Description:	
ELEVATIONS	
Project:	
GRENELL TOWER GRENELL RD, LONDON, W11 1TG	
Drawn By:	Date:
bd KVL	30.09.14
Scale:	
1:30@A3

<b>harley</b>	
HARLEY HOUSE BROOKLANDS PARK FARNINGHAM ROAD CROWBOROUGH EAST SUSSEX TN6 2JD Tel: [REDACTED]	
Drawing No:	Rev:
C1059-216	-

Project: <b>GRENFELL TOWER GRENFELL RD, LONDON. W11 1TQ</b>
Drawn By: <b>bd KVL</b>
Date: <b>30.09.14</b>
Scale: <b>1:30@A3</b>

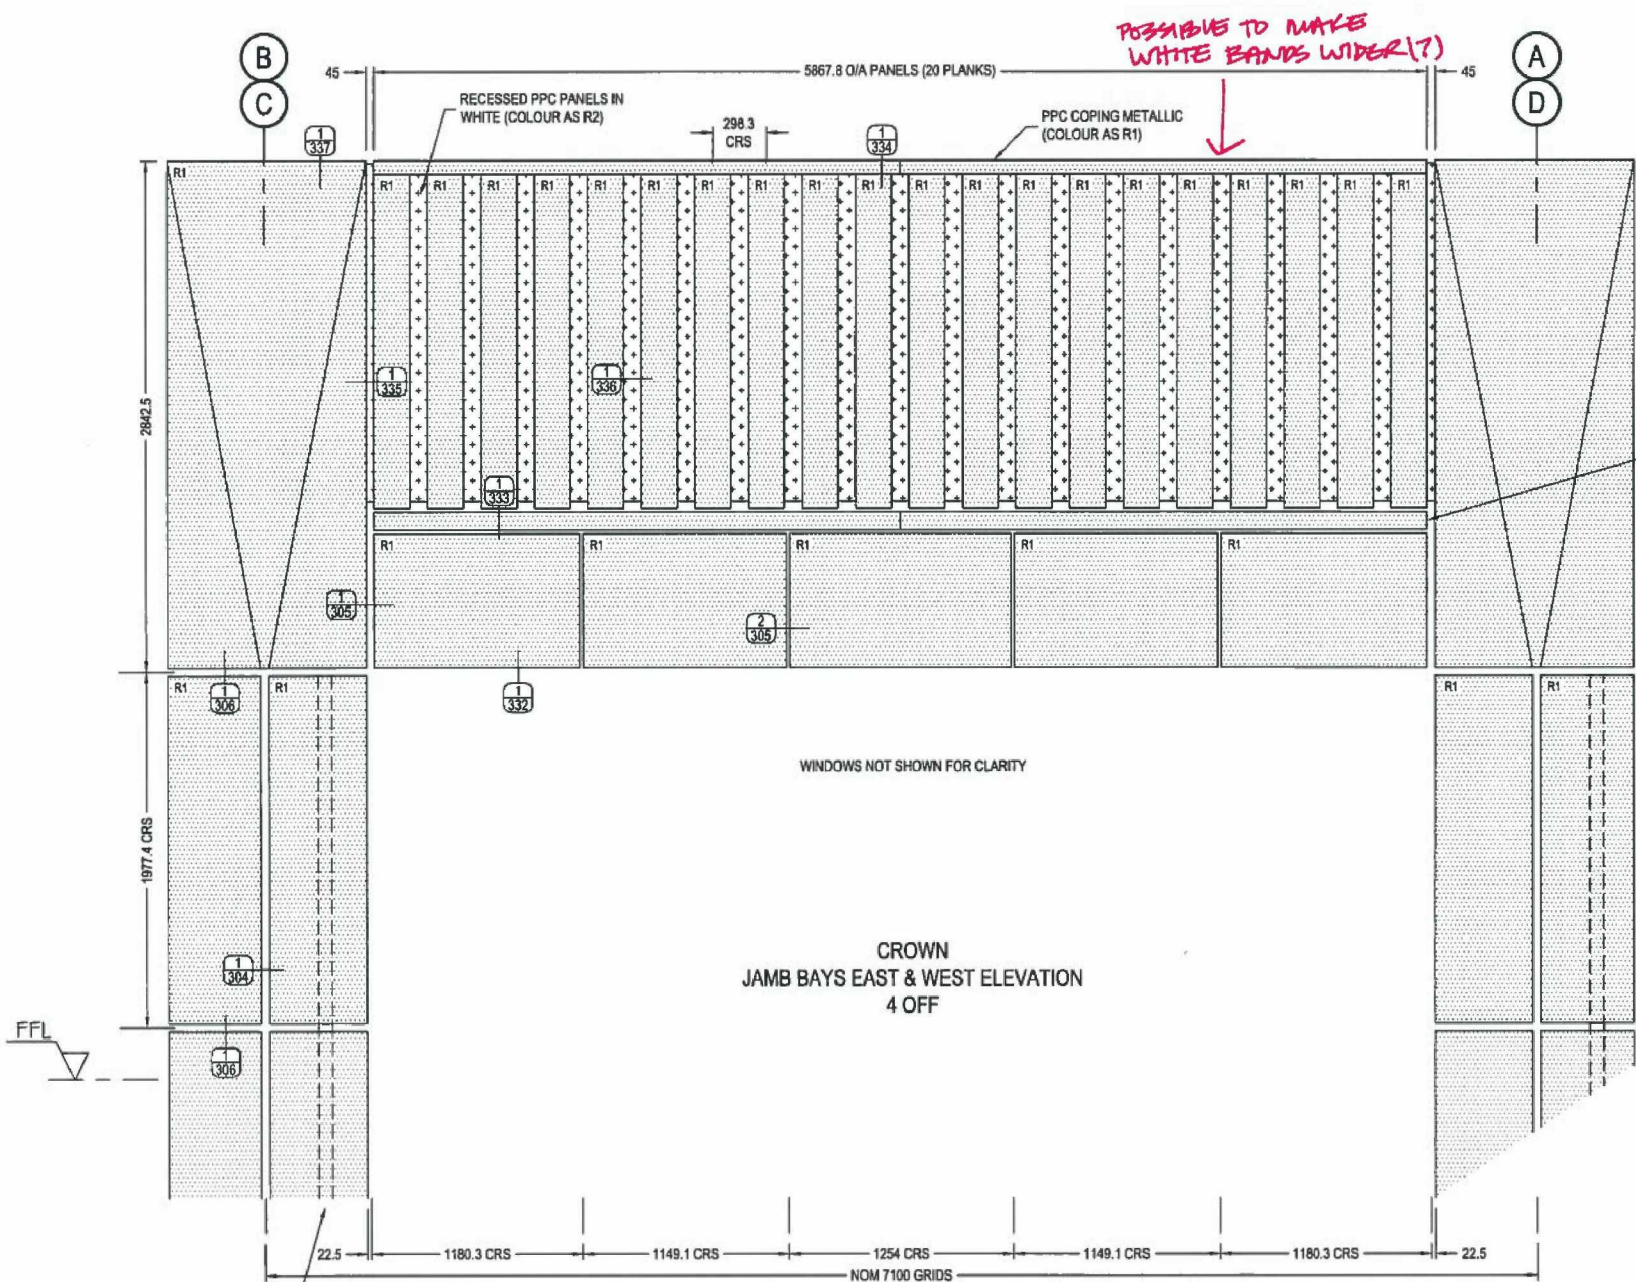
NOTE:  
VERTICAL FIREBREAKS NOT REQD ON 4 COLUMNS, IE GRIDS 2 & 4 (NORTH & SOUTH)

<b>harley</b> HARLEY HOUSE BROOKLANDS PARK FARNINGHAM ROAD CROWBOROUGH EAST SUSSEX TN6 2JD Tel: [REDACTED]	Drawing No: <b>C1059-217</b>	Rev: -
---	---------------------------------	-----------

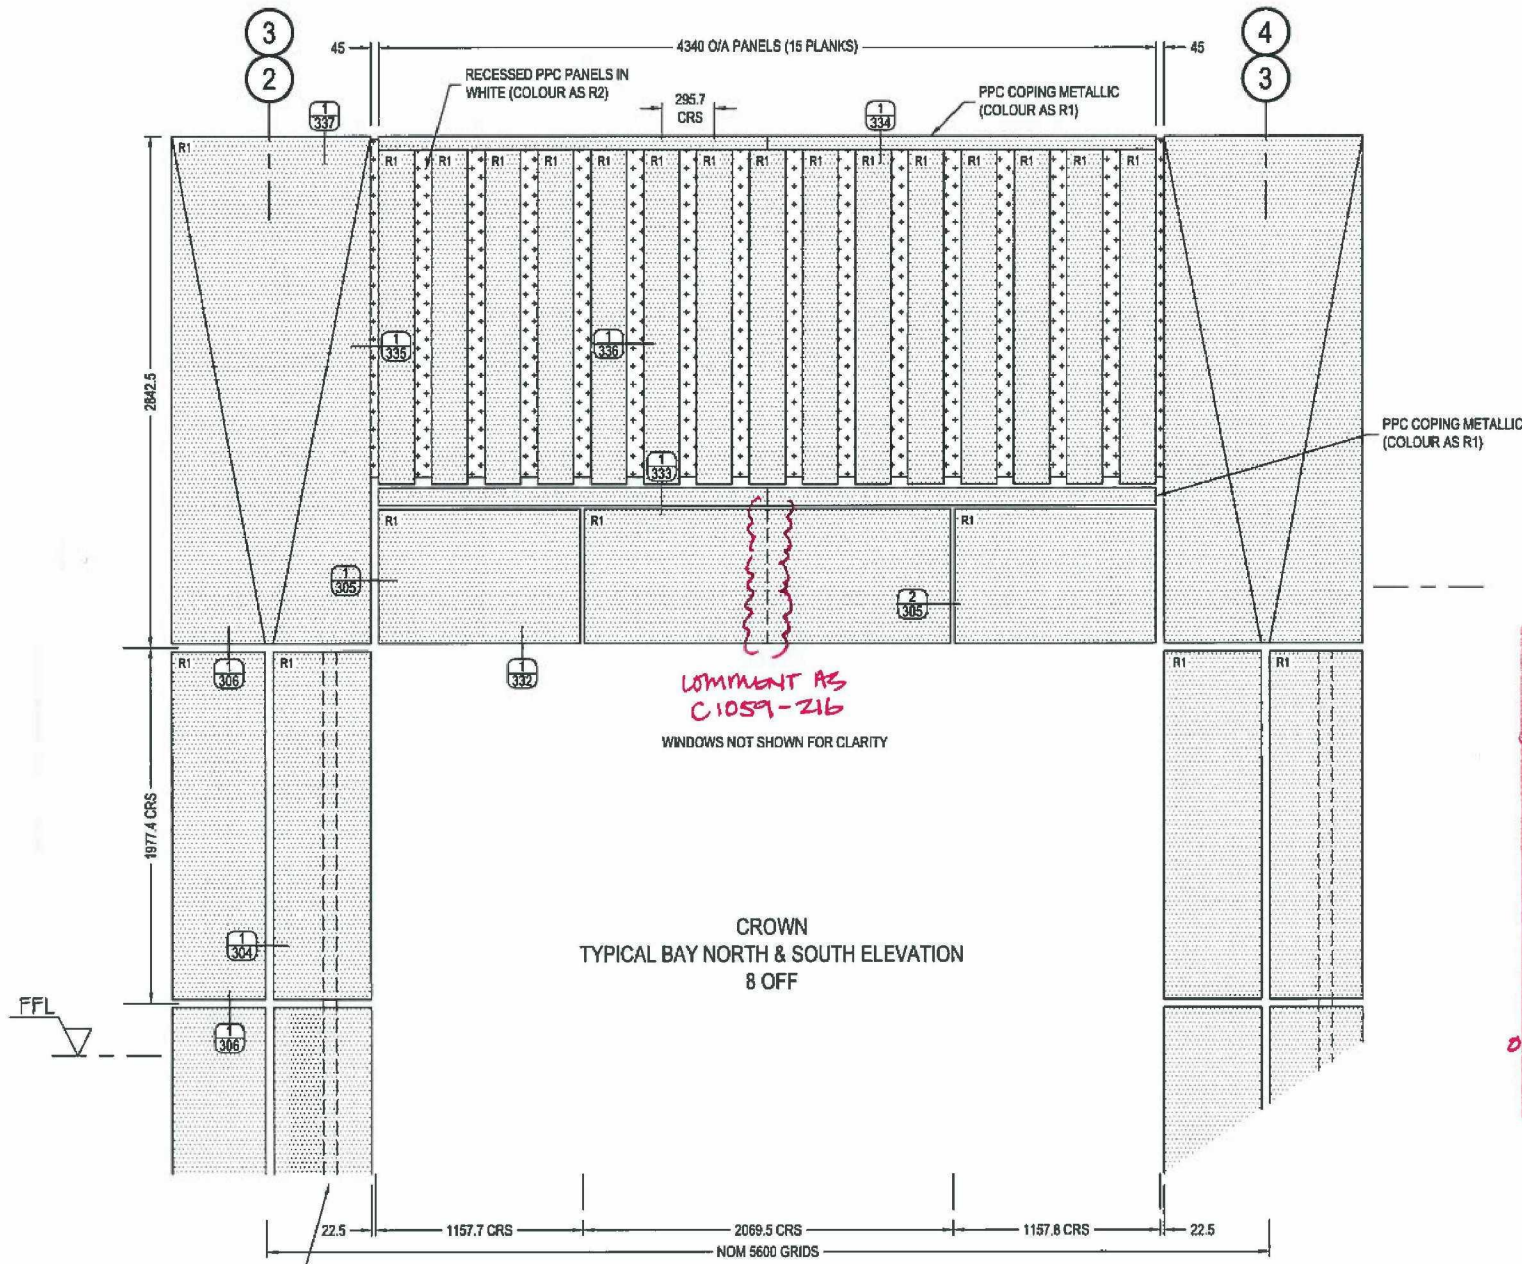
COMMENT AS  
C1059-216  
WINDOWS NOT SHOWN FOR CLARITY

Project	GRENFELL TOWER GRENFELL RD, LONDON. W11 1TQ
Drawn By	bd KVL
Date	30.09.14
Scale	1:30@A3
Client	HARLEY HOUSE BROOKLANDS PARK FARNINGHAM ROAD CROWBOROUGH EAST SUSSEX TN6 2JD Tel: [REDACTED]
Drawing No.	C1059-216
Rev.

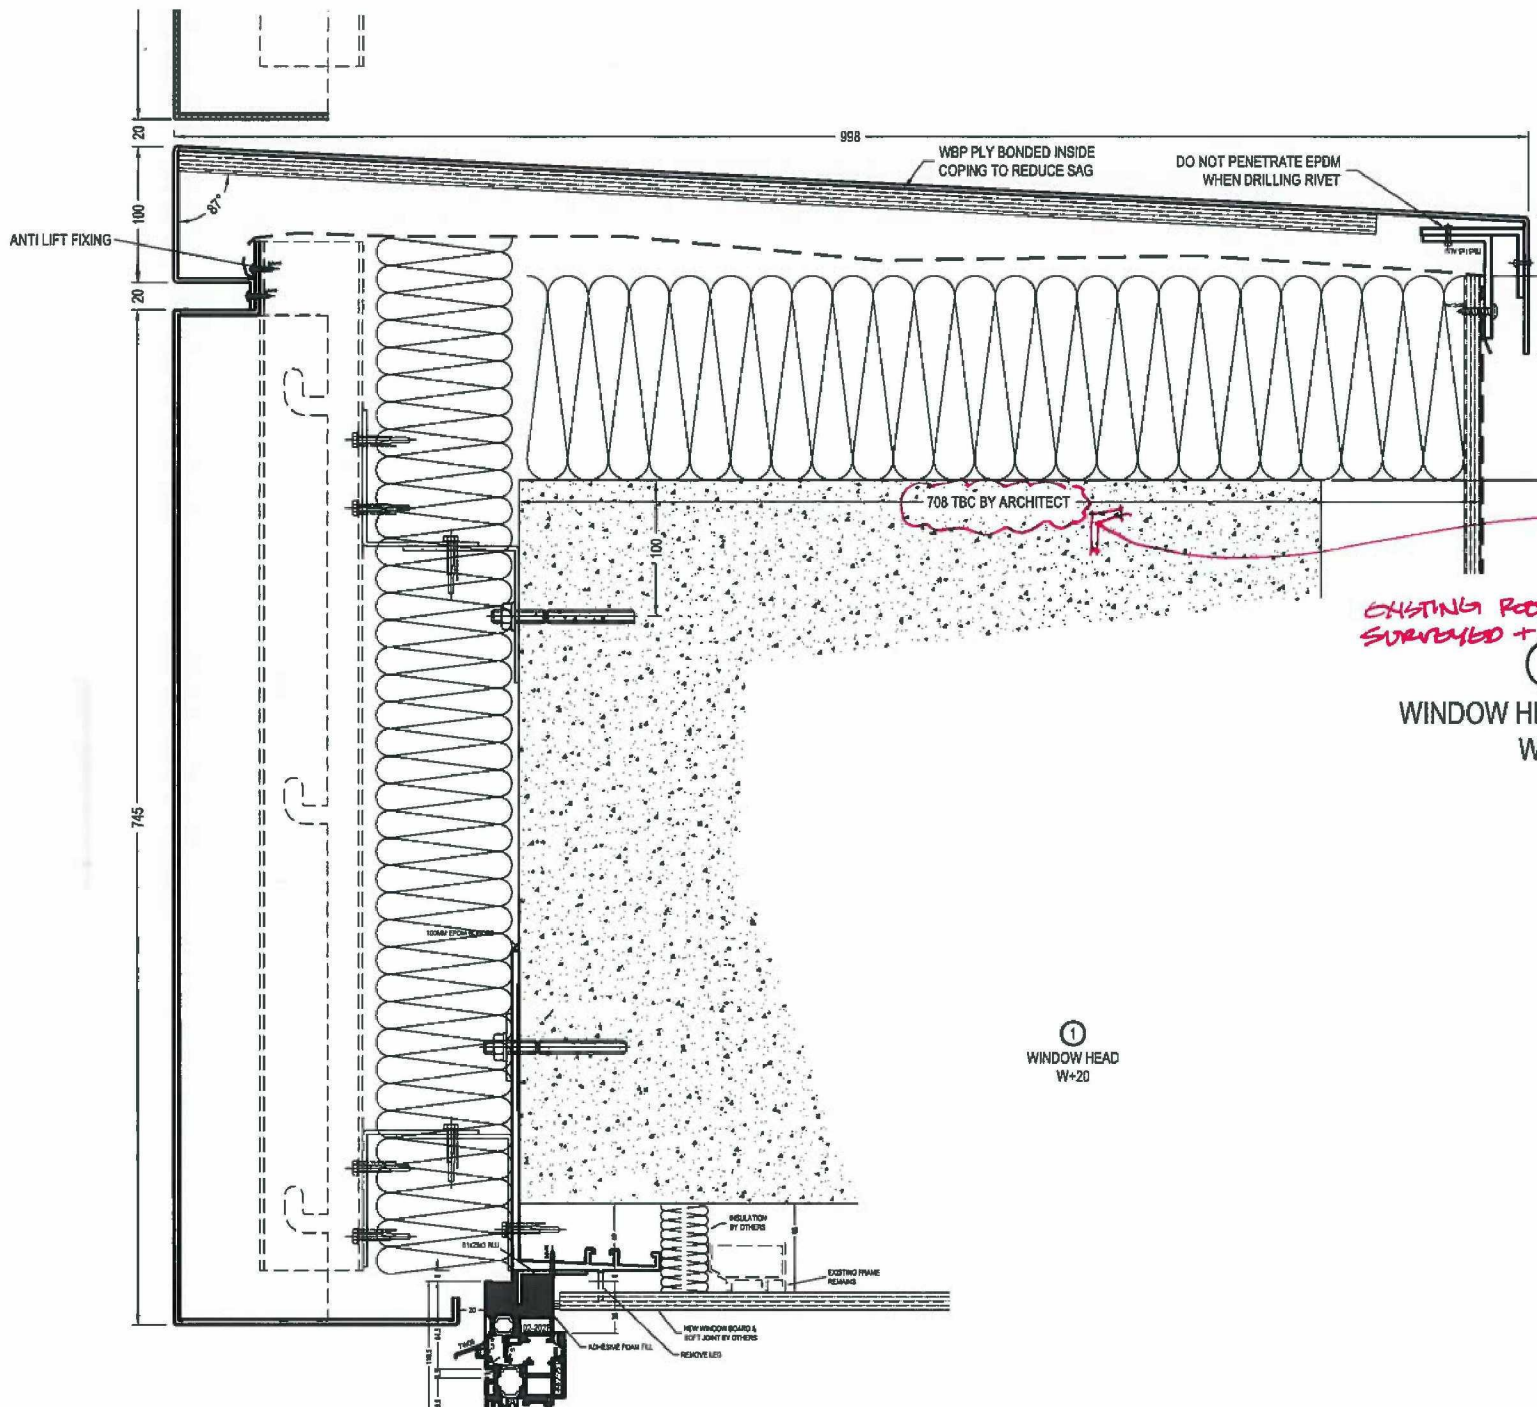
EXISTING ROOF PARAPET REQUIRES TO BE SURVEYED + METAL COPINGS / FLASHINGS TO FIT OVER. ①

①  
CROWN TOP

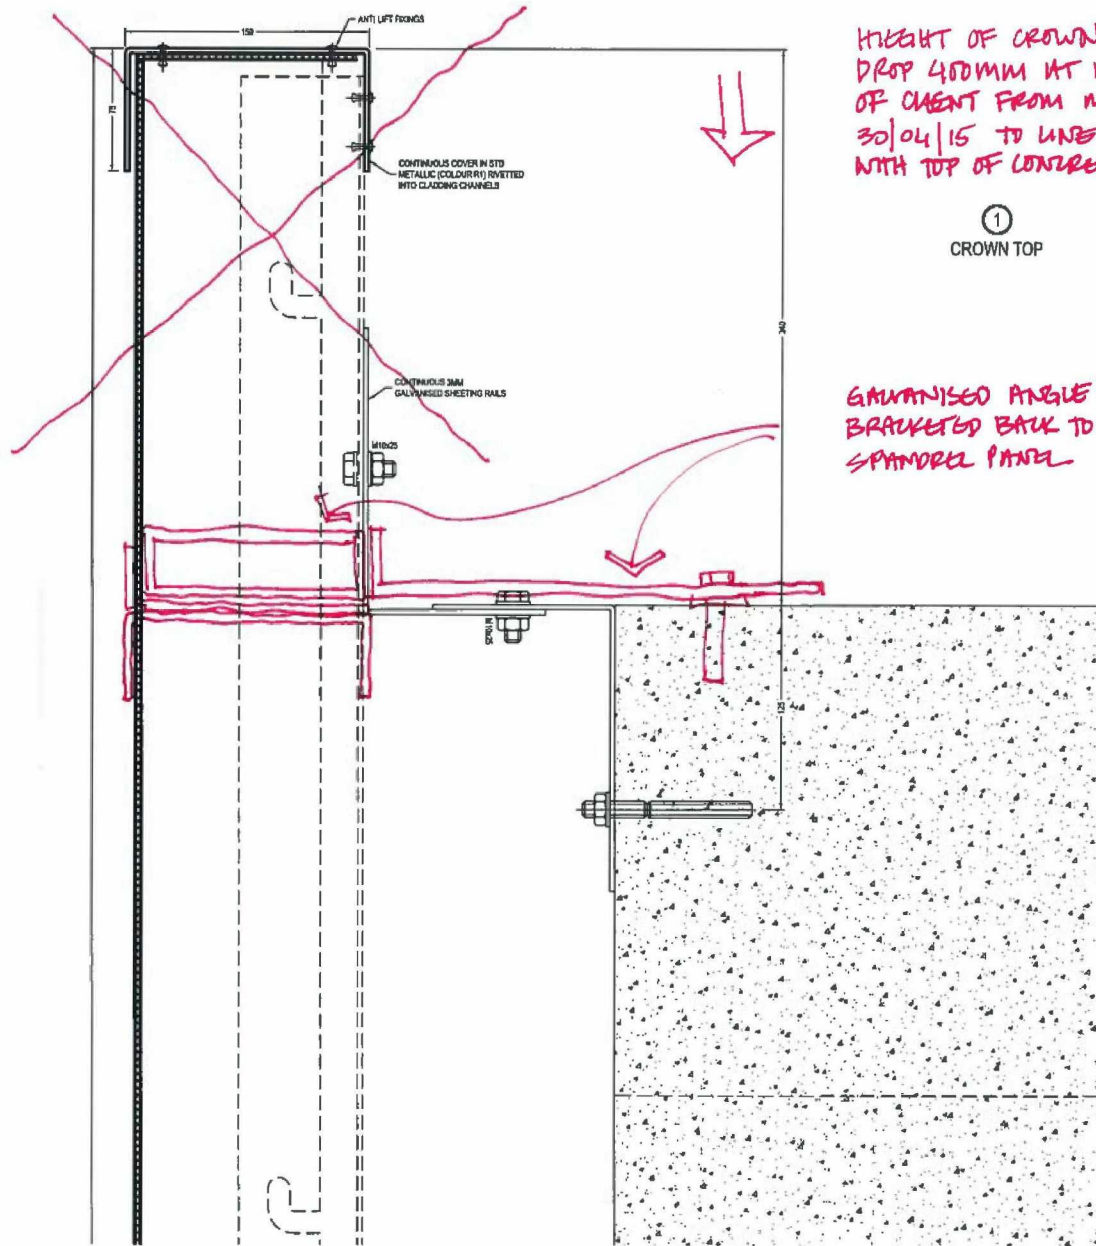
HEIGHT OF CROWN TO DROP 400MM AT REQUEST OF CLIENT FROM MEETING 30/04/15 TO LINE THROUGH WITH TOP OF CONCRETE SPANDREL.

Drawing No: C1059-334 Rev: -

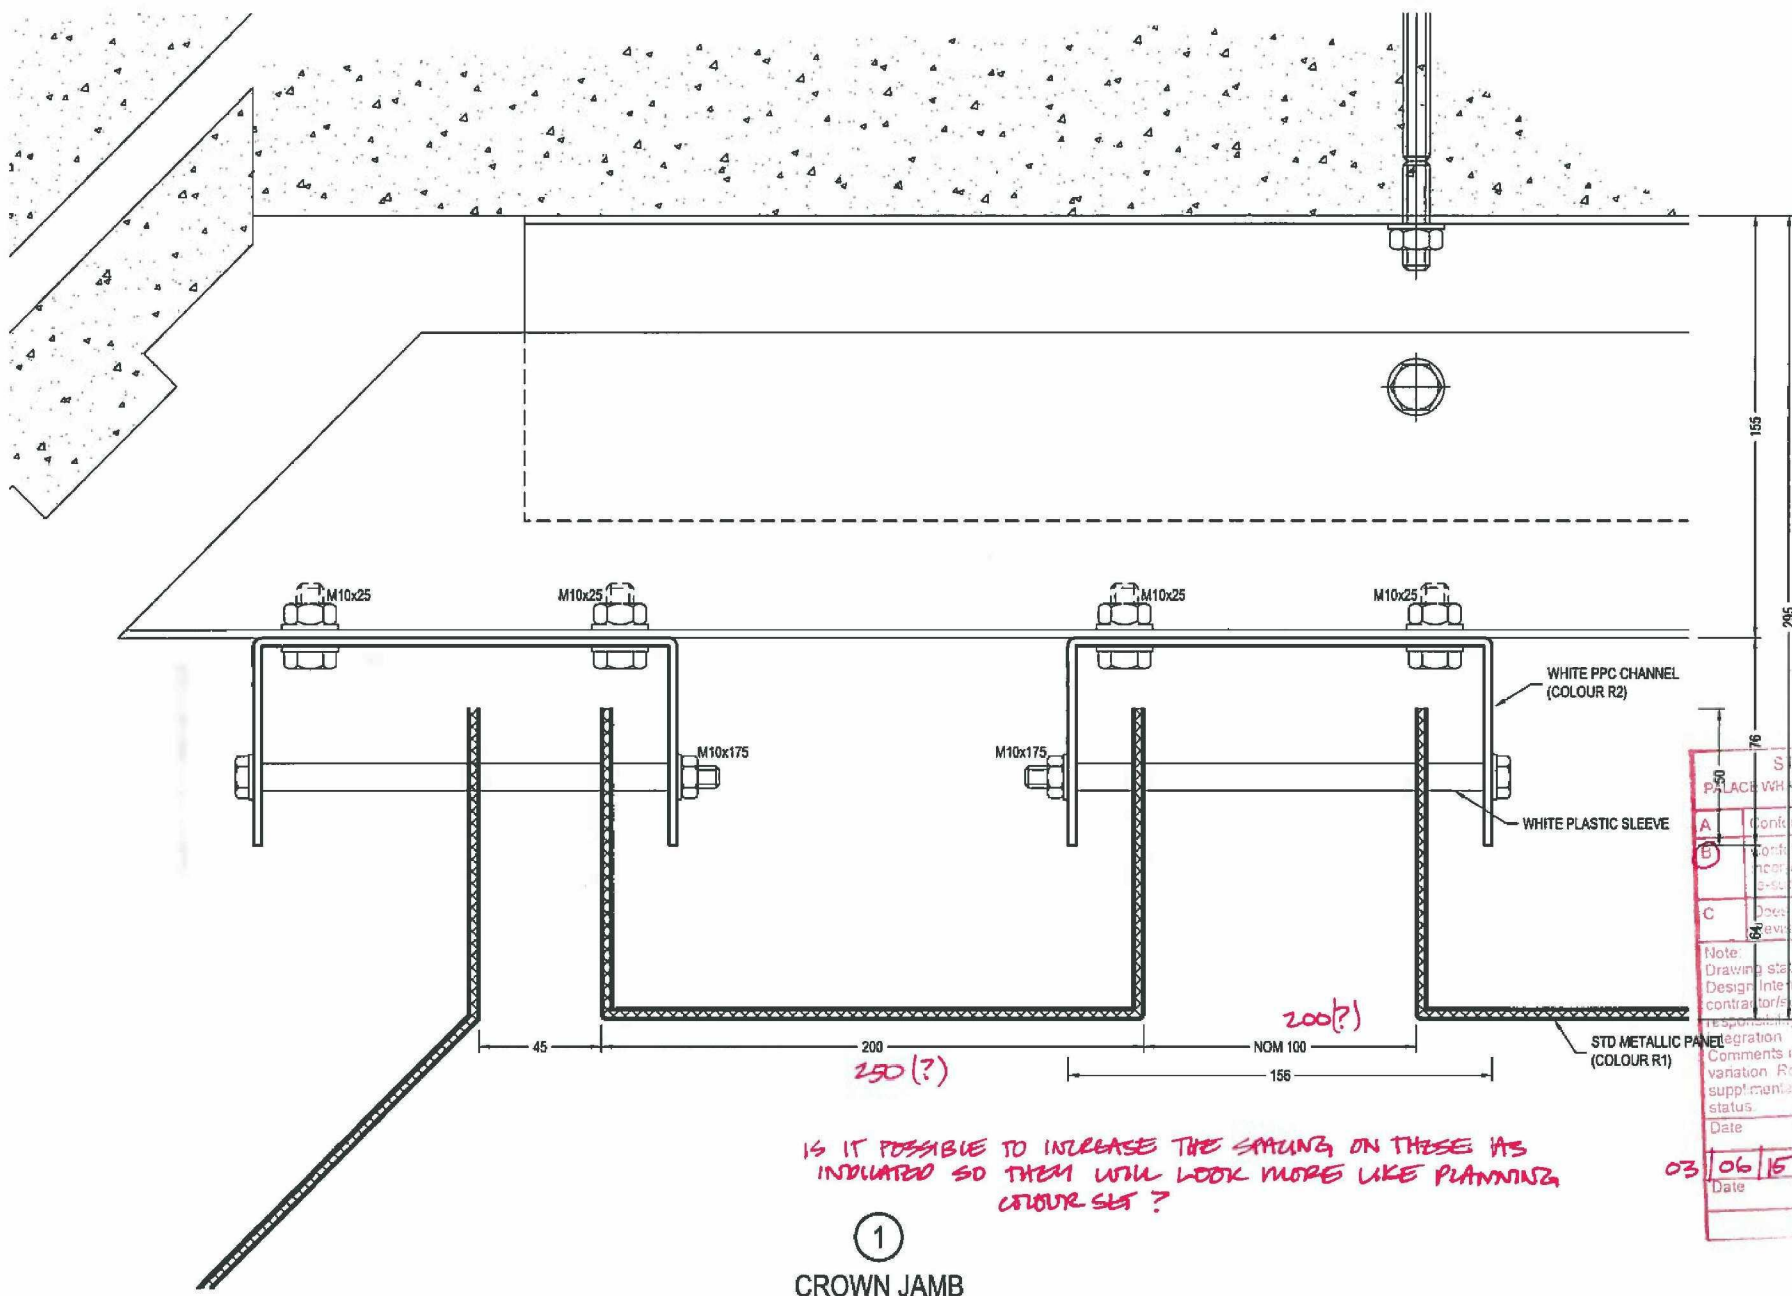
IS IT POSSIBLE TO INCREASE THE SPACING ON THESE M10x175 BOLTS INDICATED SO THEY WILL LOOK MORE LIKE PLANNING COLOUR SET ?
